Access Compliance Report

Public Rights-of-Way

Intersection ID: 10029466	Main Street: KENILWORTH_AV	Cross Street: N/A	Location: S
ADA ID: A4CE2B9253F2	Ramp Type: Directional1	Initial Pass/Fail: Fail	Overall Compliance: No
		Severity Score: 12.5

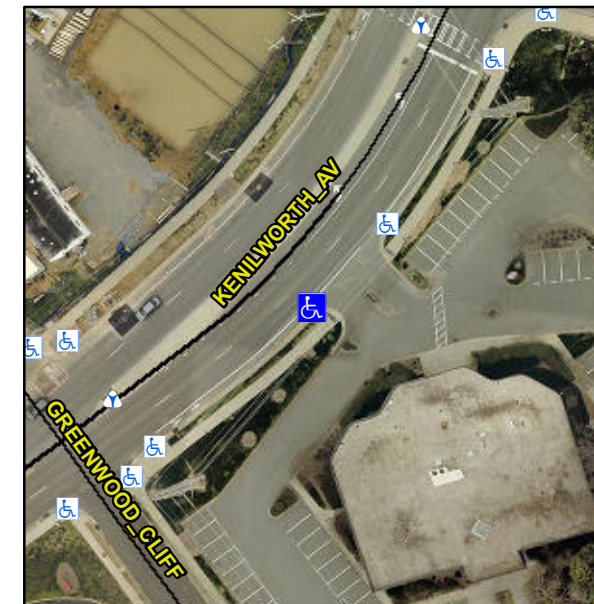
R304.2.2

Compliance	Description	Data	Compliance	Description	Data
N/A	Ramp Length (in)	84.0	N/A	Grade Break?	N/A
Yes	Ramp Width (in)	70.0	N/A	Grade Break Slope (%)	0.0
No	Ramp Slope (%)	8.8	N/A	Grade Break XSlope (%)	0.0
Yes	Ramp XSlope (%)	0.6			
N/A	Flare Type LT	N/A	N/A	Flare Type RT	N/A
N/A	Flare Slope LT (%)	N/A	N/A	Flare Slope RT (%)	0.0
N/A	Flare Traversable LT?	N/A	N/A	Flare Traversable RT?	N/A
N/A	Landing Length (in)	0.0	N/A	DWS Provided?	N/A
N/A	Landing Width (in)	0.0	N/A	DWS Contrast?	N/A
N/A	Landing Slope (%)	0.0	N/A	DWS Length (in)	N/A
N/A	Landing X Slope (%)	0.0	N/A	DWS Full Width?	N/A
N/A	Landing Curb? (Y/N)	N/A	N/A	DWS Offset LT (in)	N/A
N/A	Shared Landing?	N/A	N/A	DWS Offset RT (in)	N/A
N/A	Gutter Ponding?	0.0	N/A	Gutter Slope (%)	N/A
N/A	Gutter Lip Ht (in)	0.0	N/A	Gutter X Slope (%)	N/A
N/A	Painted X Walk1?	No		Road Slope (%)	0.2
	X Walk 1 Direction	To NE		Road X Slope (%)	4.1
	X Walk 1 Width (in)	N/A		Clear Space?	N/A

Remove & Replace Entire Ramp.
